**Amendments to the Drawings:**

## REMARKS/ARGUMENTS

Annotated Marked-up Drawings

FIG. 3

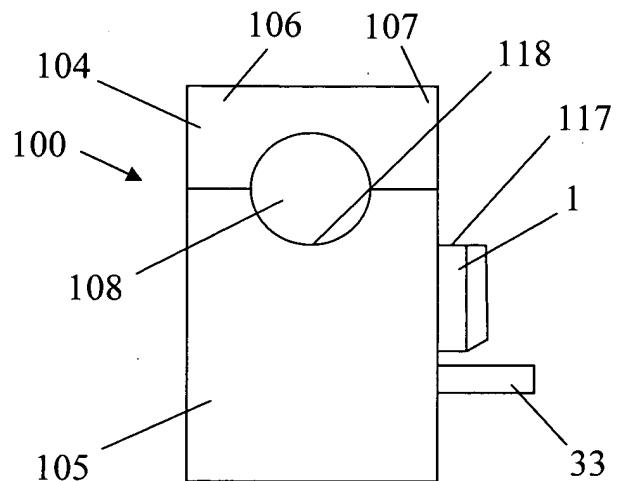
The attached replacement sheet shows reference character **117** with a lead line designating the uppermost portion **117** of the housing **1** as well as reference character **118** with a lead line designating the lowermost portion of aperture **108** and reference character **119** with a lead line designating the lowermost portion of aperture **114**.

A new paragraph has been added explaining that housing **1** is preferably so attached to the first clamp **100** and to the second clamp **102** that the uppermost portion **117** of the housing **1** is lower than the lowermost portion **118** of the aperture **108** and the lowermost portion **119** of the aperture **114**. FIGS. 3 and 4 have had the necessary new reference characters and lead lines added.
